**RE: Monitoring Recommendation Update
Proposed Capital Paving Inc. Montrose Pit.**

Further to the November 25, 2009 meeting held with the Region of Waterloo regarding initial findings of the Region's review of the Capital Paving Inc. Proposed Montrose Pit Scoped Subwatershed Study (September 11, 2009), we are providing an updated set of monitoring program recommendations for the site. The recommendations include some additional water level and water quality monitoring at the site during operations and the development of initial threshold values in response to the concerns expressed at the meeting. Overall, the recommendations provide a substantial level of protection for both natural environment features (wetlands, streams, etc.) and local water wells.

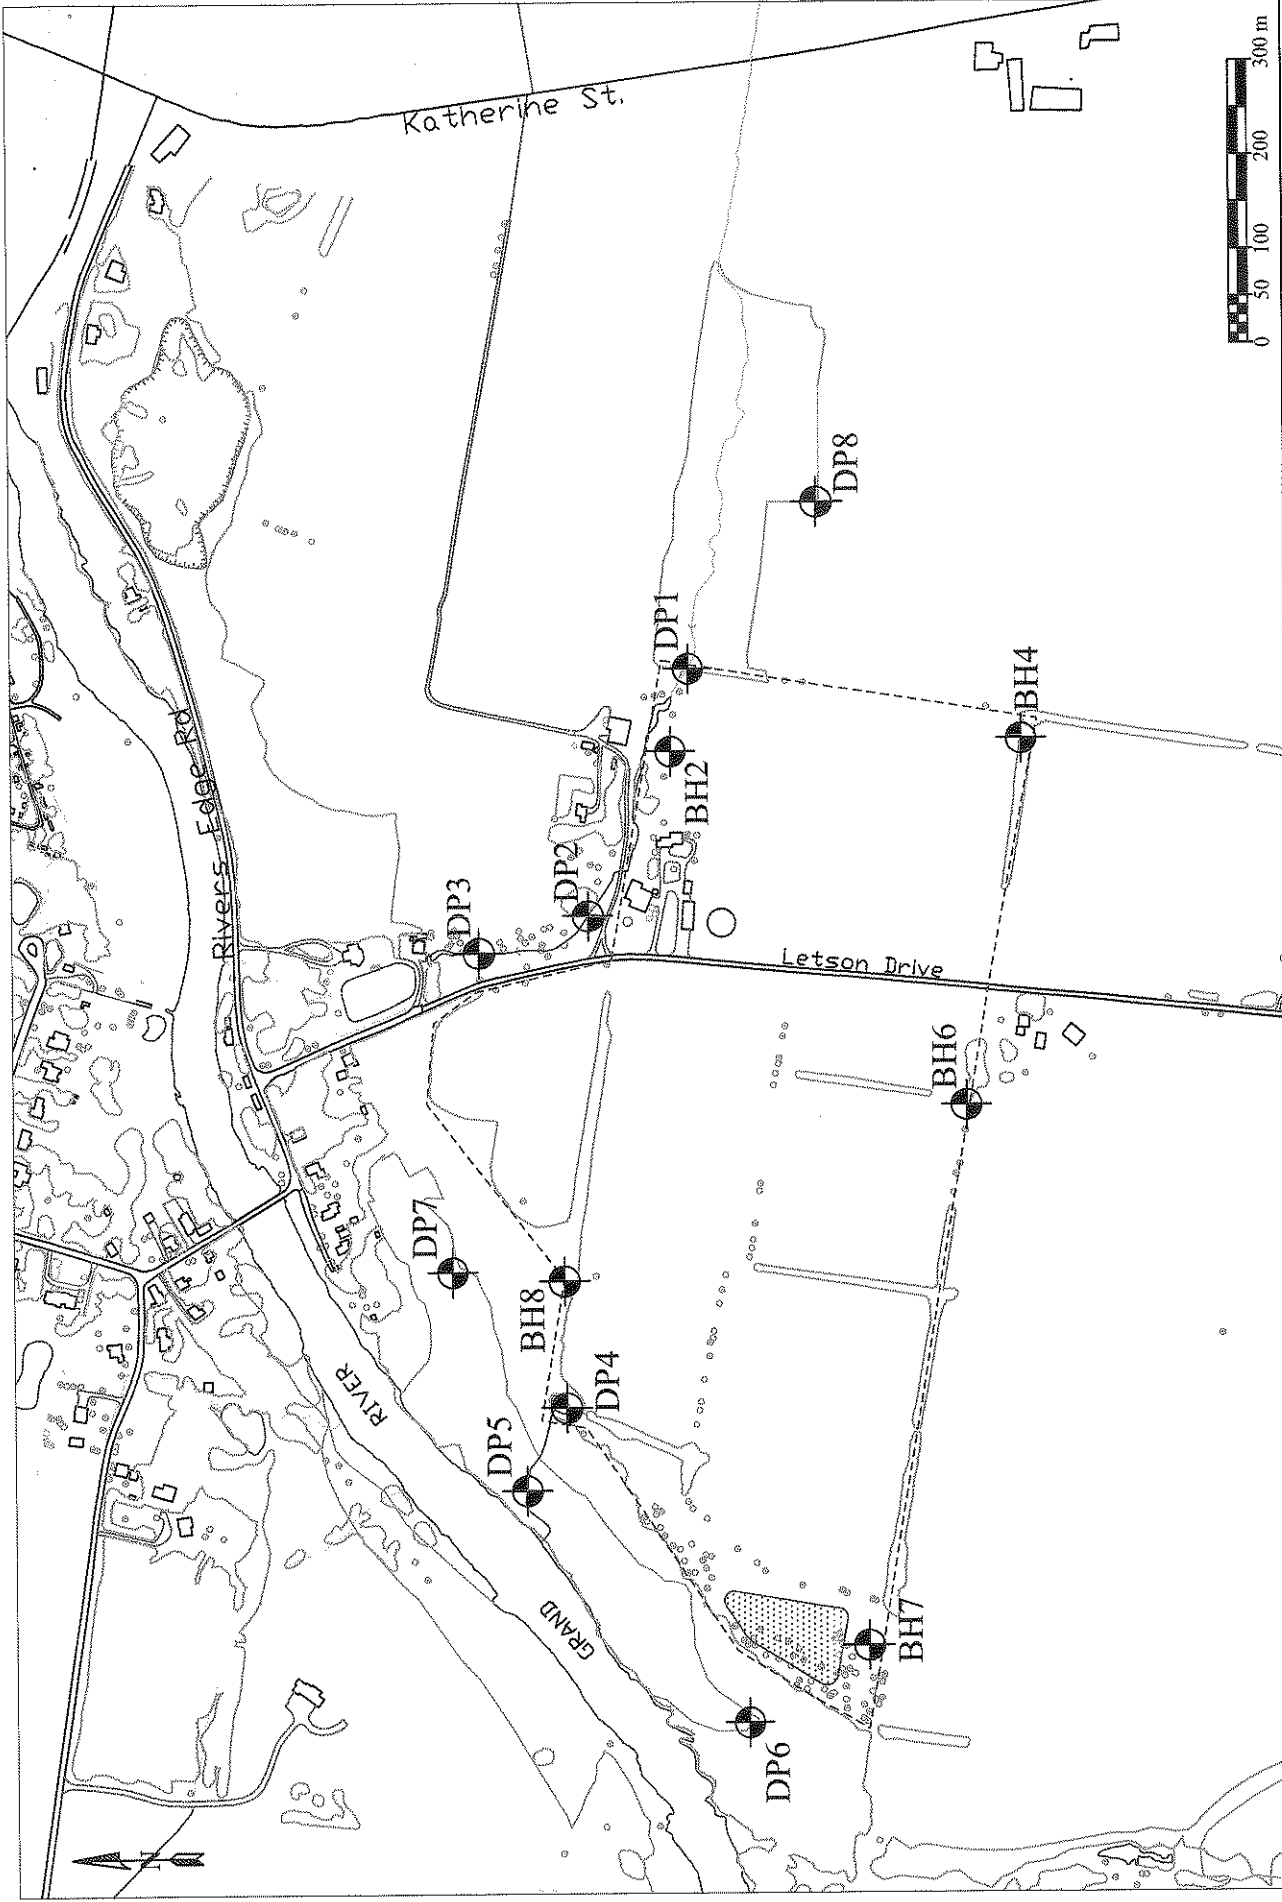
- there is general agreement that localized impacts are not expected on a local or subwatershed scale, however there are some questions regarding the effects of water taking;
- a robust monitoring program is the "key" to ensuring the Region that impacts will not occur;
- water level monitoring specific to proposed water taking operations should occur to ensure any potential associated water level changes do not extend to natural environment features or wells;
- additional water level monitoring locations should be installed to provide information east of the site and near the northwest corner of the site;
- enhanced water quality monitoring should occur; and,
- initial threshold levels for Extraction Phases 1 to 4 should be developed now.

Two additional water level monitoring locations are proposed to be installed before extraction operations begin. The locations are shown on the attached figure. These locations would be monitored manually at the frequency proposed for all other locations. One drive-point (DP 7) would be installed within the "slope seep" location north of BH8 (see Scoped Watershed Study Figure 7.0). This location would serve to monitor conditions between the site and the river, and between the water taking and the private wells. One monitoring well or drive-point (DP8) would be installed on the adjacent property east of the site, likely along the edge of the woodlot. This location would provide an indication of the extent of any water level change east of the site.

- Prior to extraction at the site monitors DP7 and DP8 (completed as drive-points or water table monitoring wells) shall be installed.
- Stilling wells shall be installed in the wash water source pond and the silt pond as soon as possible after the ponds are constructed.
